ADDENDUM
NO. 1

July 16, 2020

Additions & Renovations to Lawrence North High School
7802 Hague Road
Indianapolis, IN 46256

PREPARED BY SCHMIDT ASSOCIATES FOR:
LAWRENCE NORTH HIGH SCHOOL RENOVATION
LAWRENCE TOWNSHIP, M.S.D. OF

18 TYPICAL BEAM-TO-COLUMN MOMENT CONNECTIONS
3/4" = 1'-0"

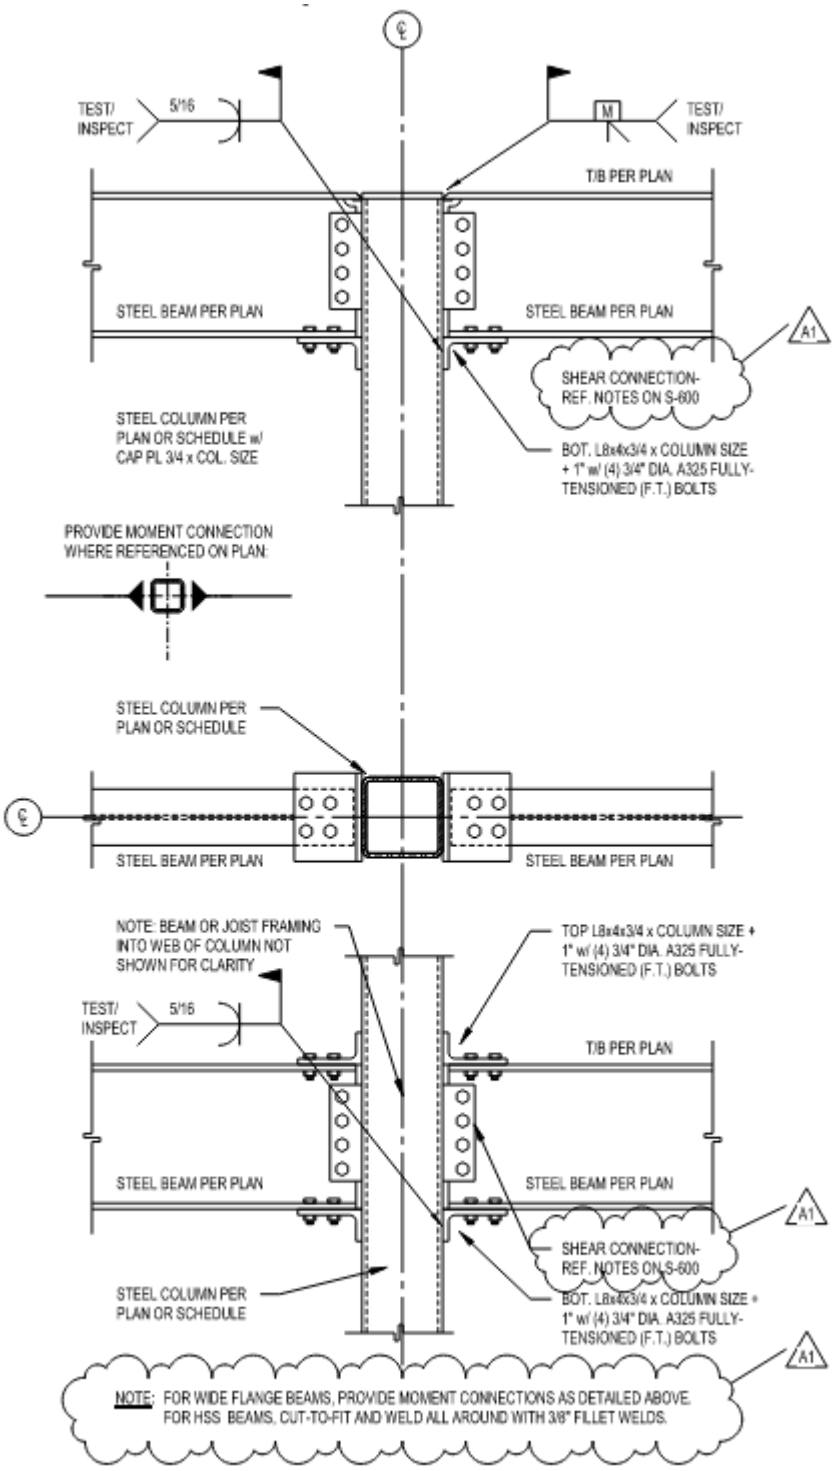
2. In Detail 18/S-501, modify the detail as shown below:

A. Drawing Number IN1H1

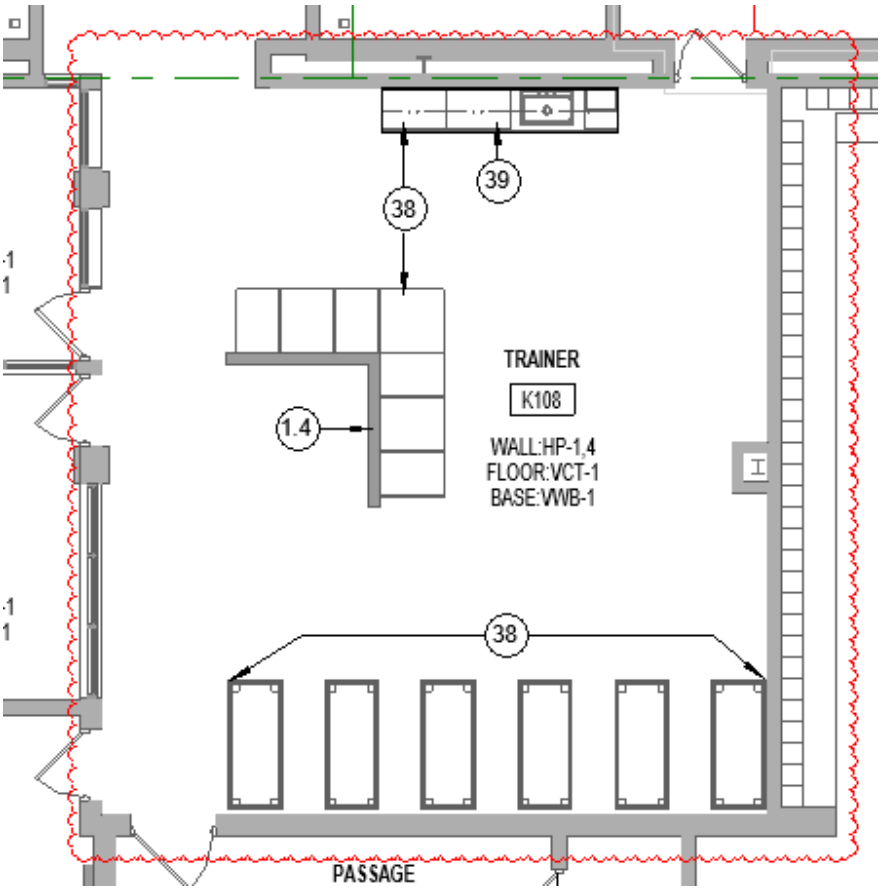
1. ADD Notes 38 & 39 to Drawing as follows:

"#38 - EXISTING CASEWORK (& FREESTANDING TRAINING TABLES) TO BE SALVAGED AND REINSTALLED IN CURRENT CONFIGURATION. VERIFY EXACT PLACEMENT IN FIELD PRIOR TO DEMOLITION OF EXISTING FINISHES."

"#39 - 12 32 00 - PROVIDE NEW COUNTERTOP W/ 4" BACKSPLASH TO BE PL-2. VERIFY OVERALL DIMENSIONS IN FIELD TO MATCH EXISTING CASEWORK CONFIGURATION."

A. **Drawing Number MDH1H1**

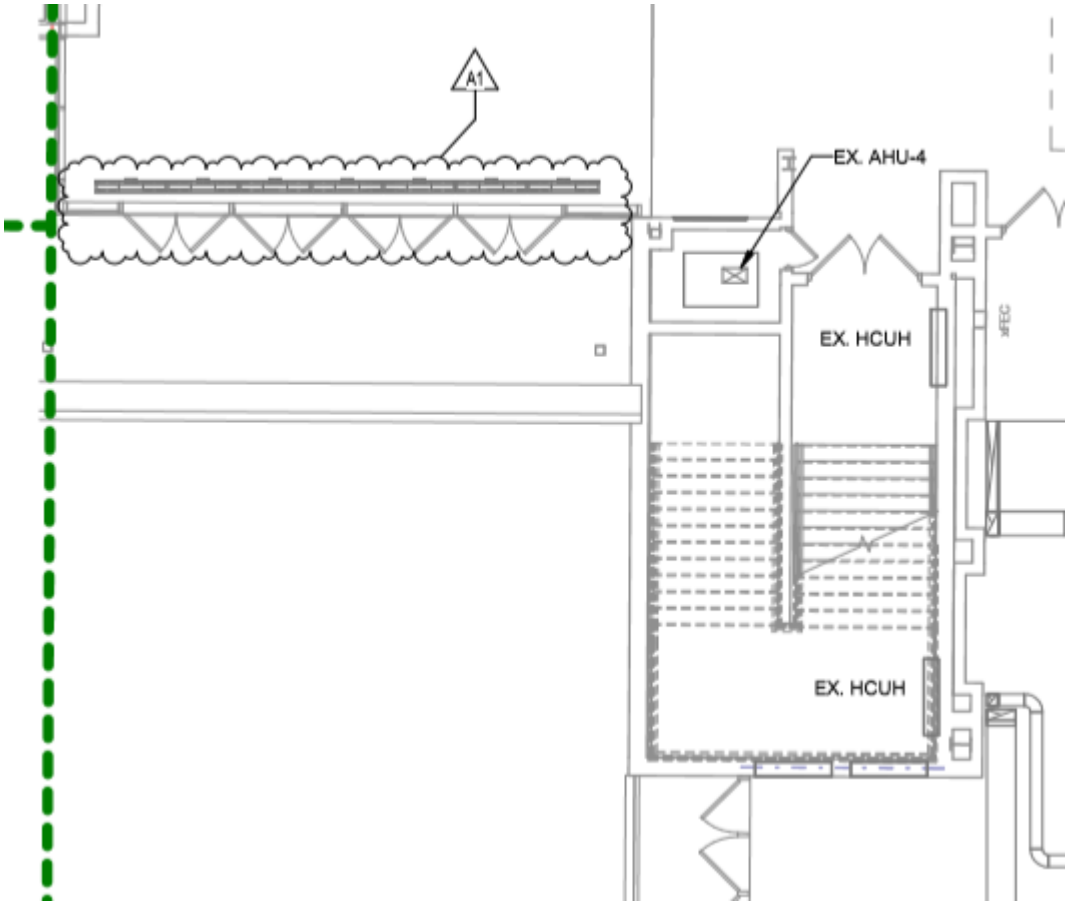
1. MODIFY drawing to remove existing grilles as follows:

B. **Drawing Number MDH1H2**

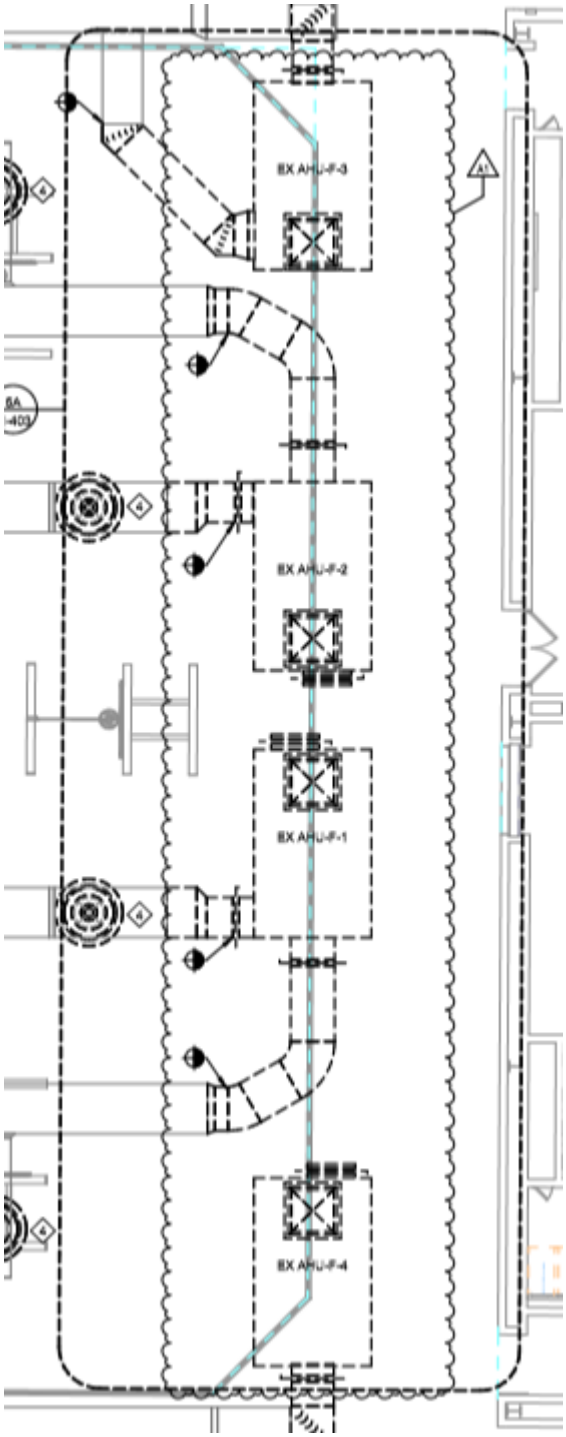
1. MODIFY drawing to remove existing ductwork, AHU's and intake vents as follows:

C. **Drawing Number MDH1J1**

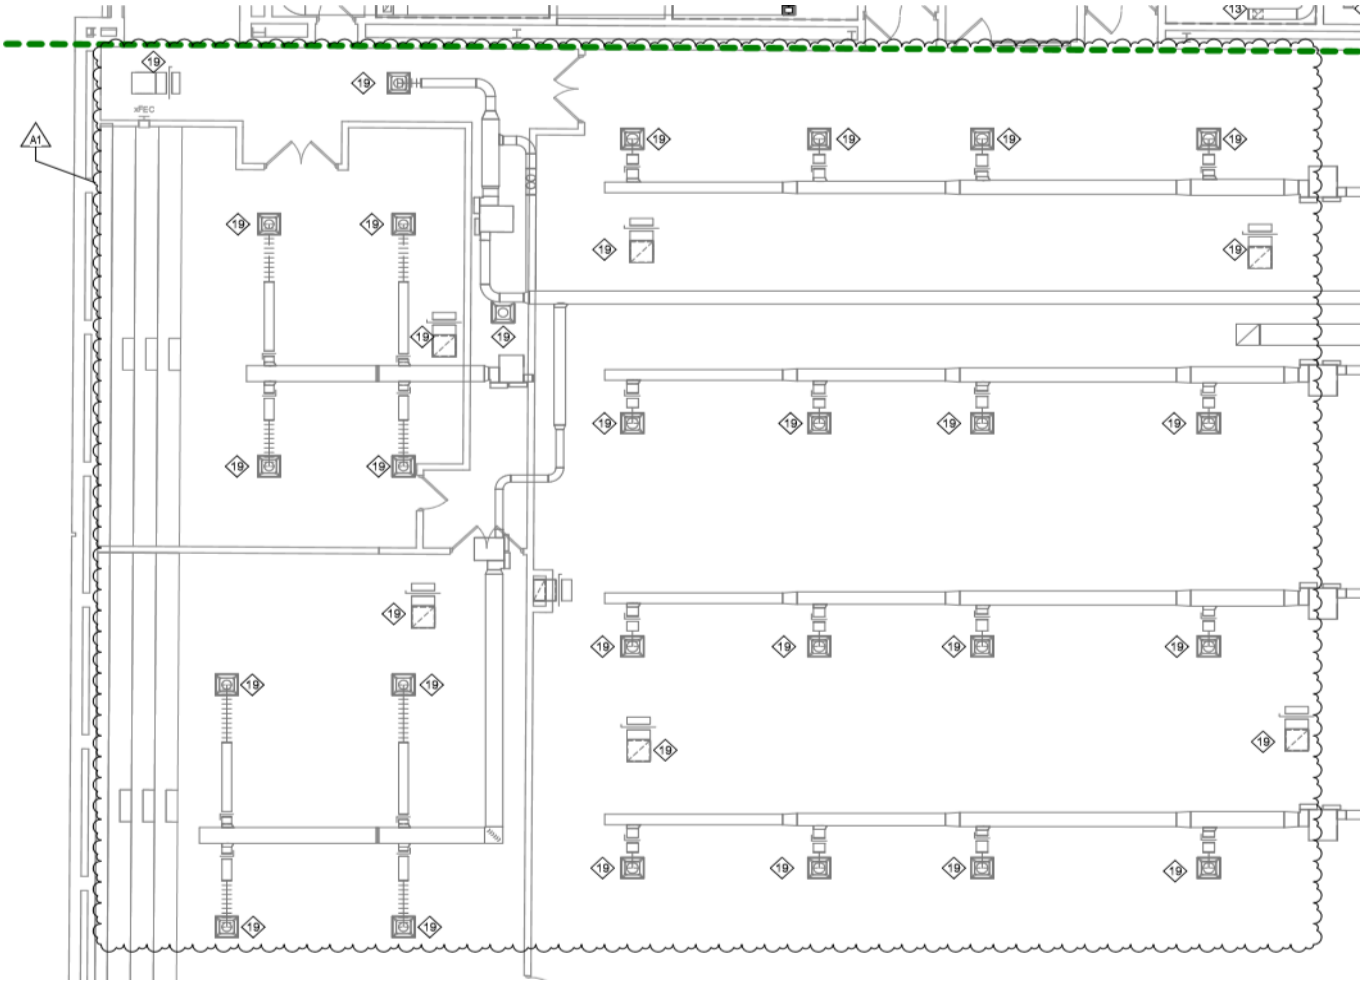
1. MODIFY drawing to remove existing diffuser or grille. Clean and protect for placement in new ceiling grid as follows:

D. **Drawing Number MDH1K1**

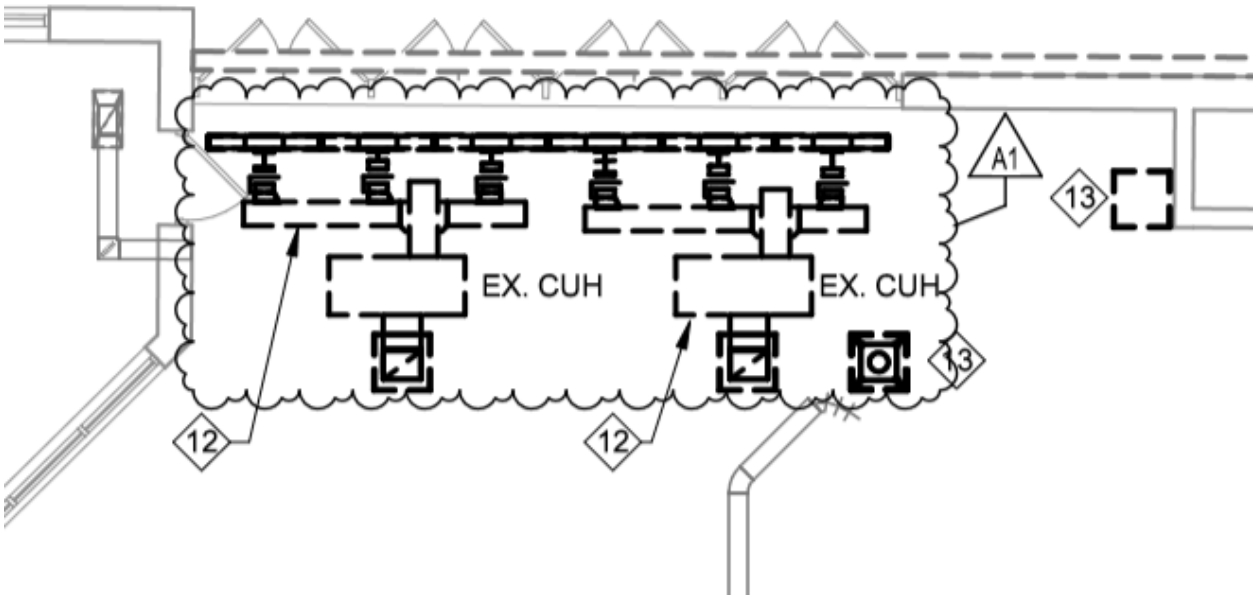
1. MODIFY drawing to remove existing CUH, associated ductwork, and diffusers as follows:

F. **Drawing Number MDP1D1**

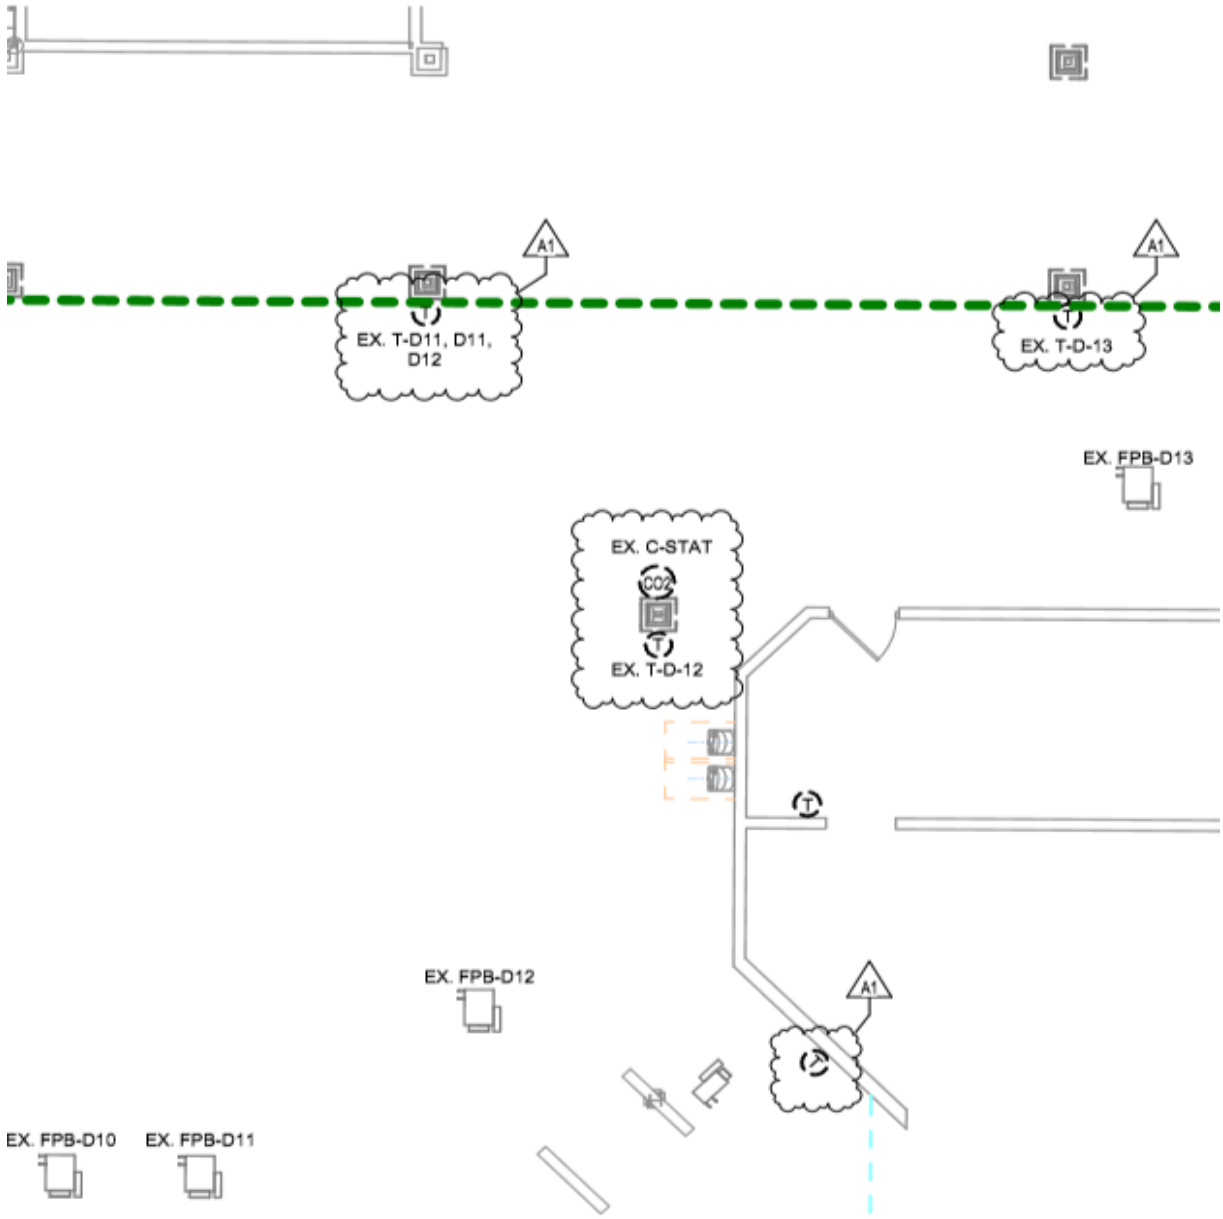
1. MODIFY drawing to remove existing thermostat as follows:

G. **Drawing Number MDP1D1**

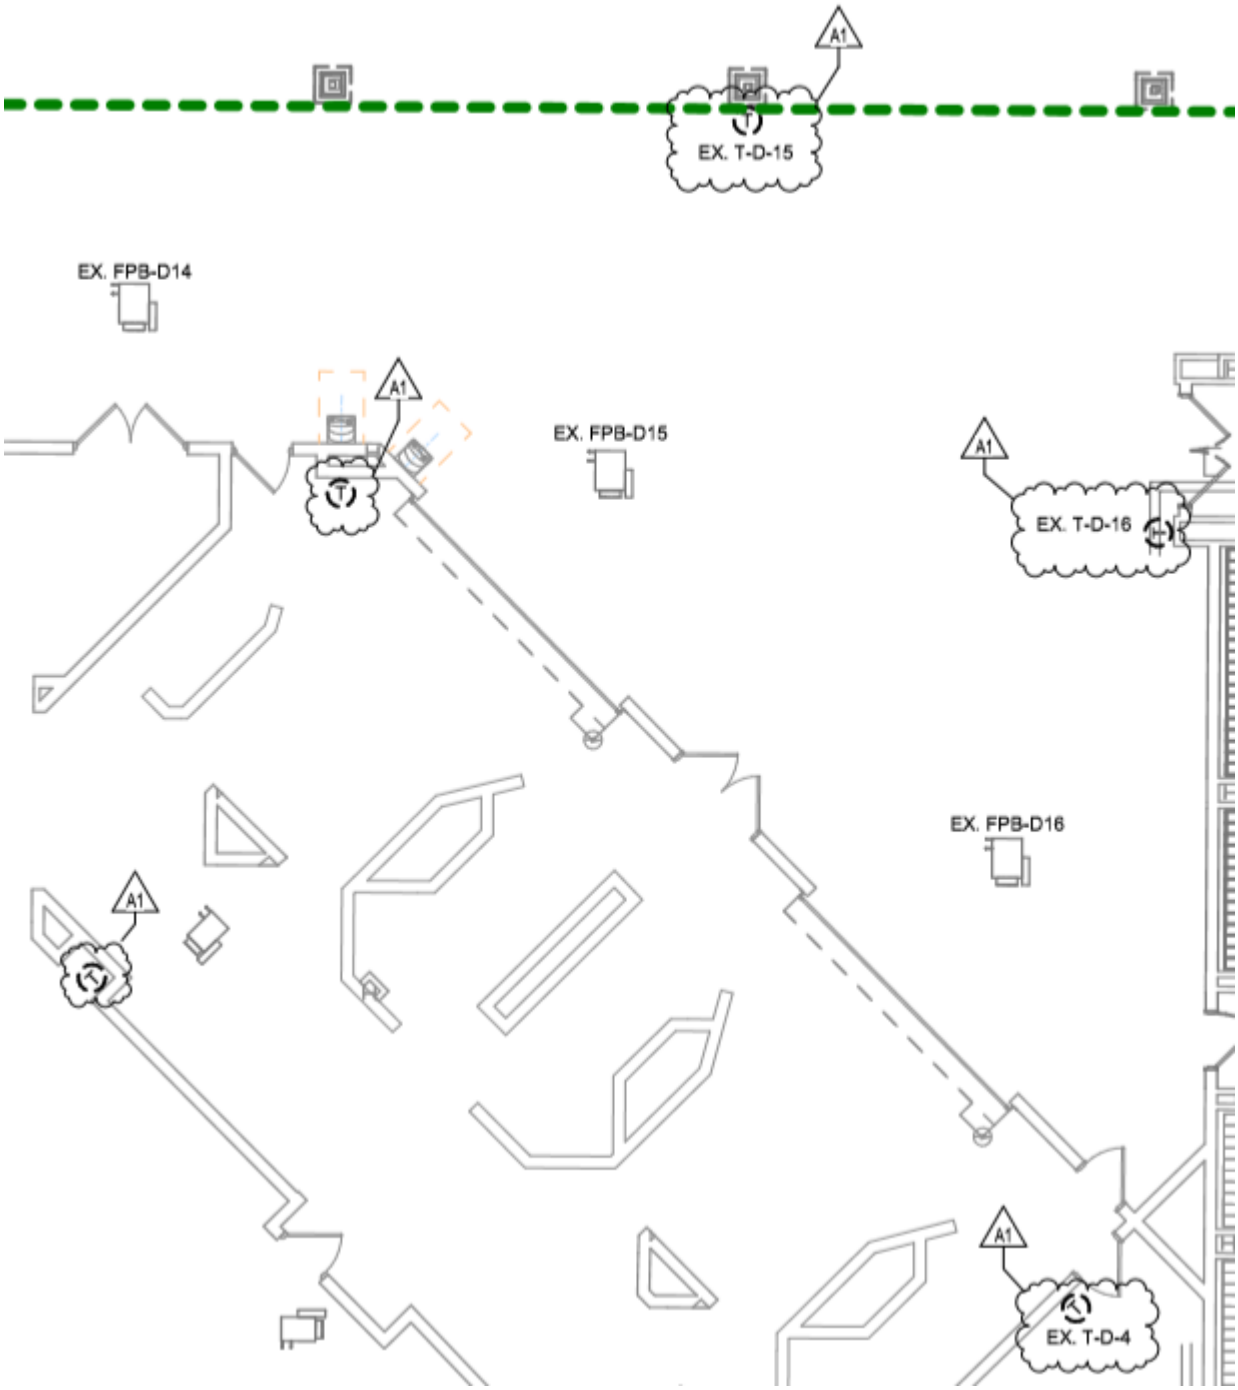
1. MODIFY drawing to remove existing thermostat as follows.

H. **Drawing Number MDP1D1**

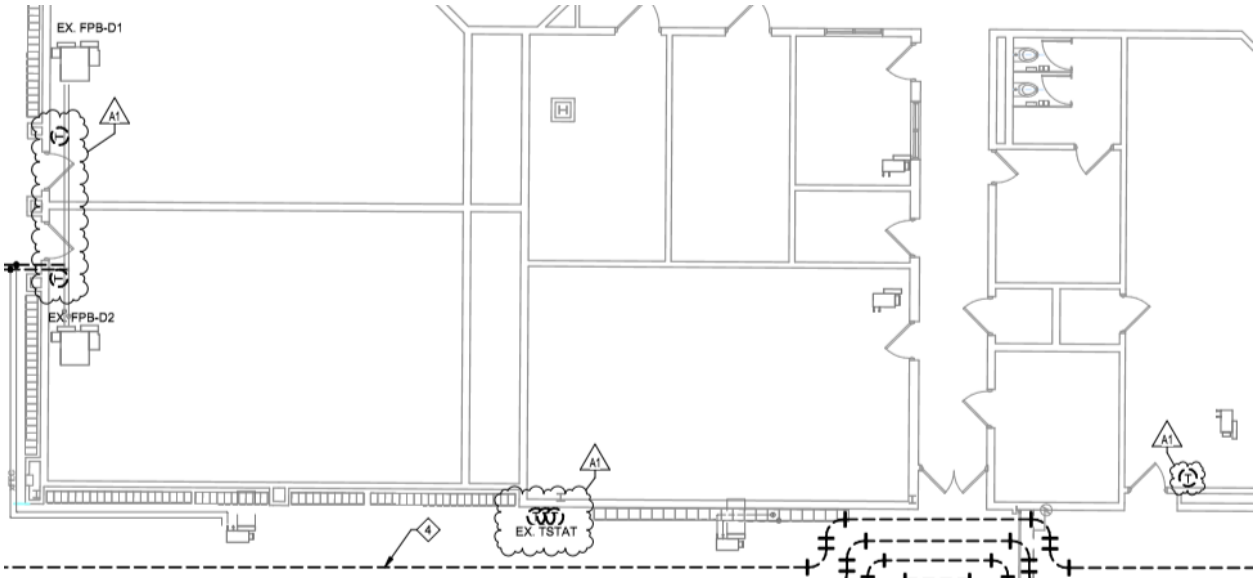
1. MODIFY drawing to remove existing thermostat as follows:

L. **Drawing Number MDP1E1**

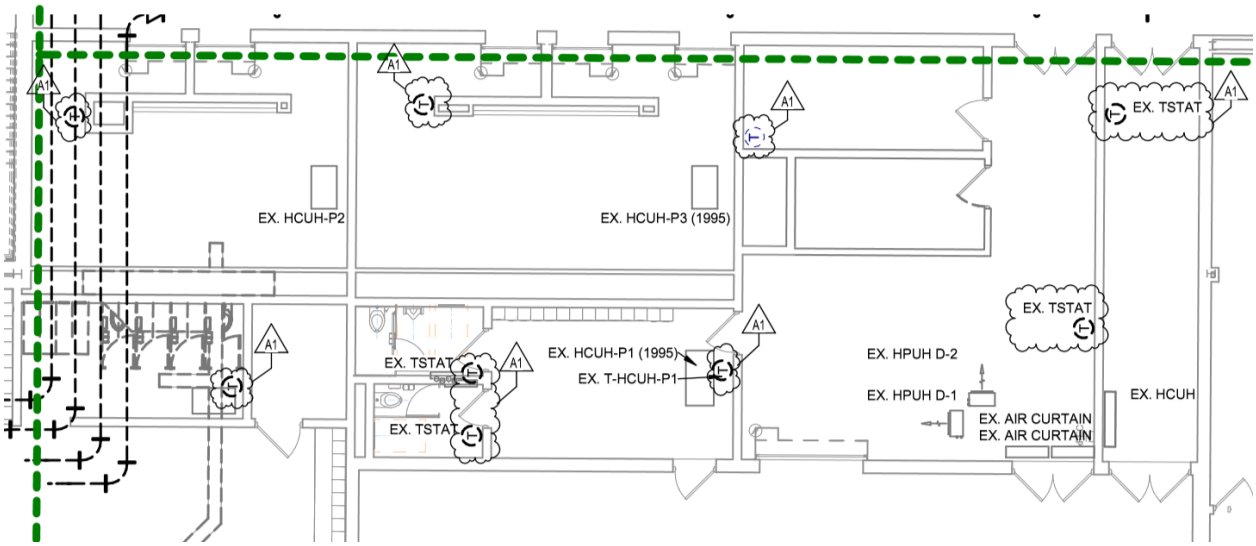
1. MODIFY drawing to remove existing thermostat as follows:
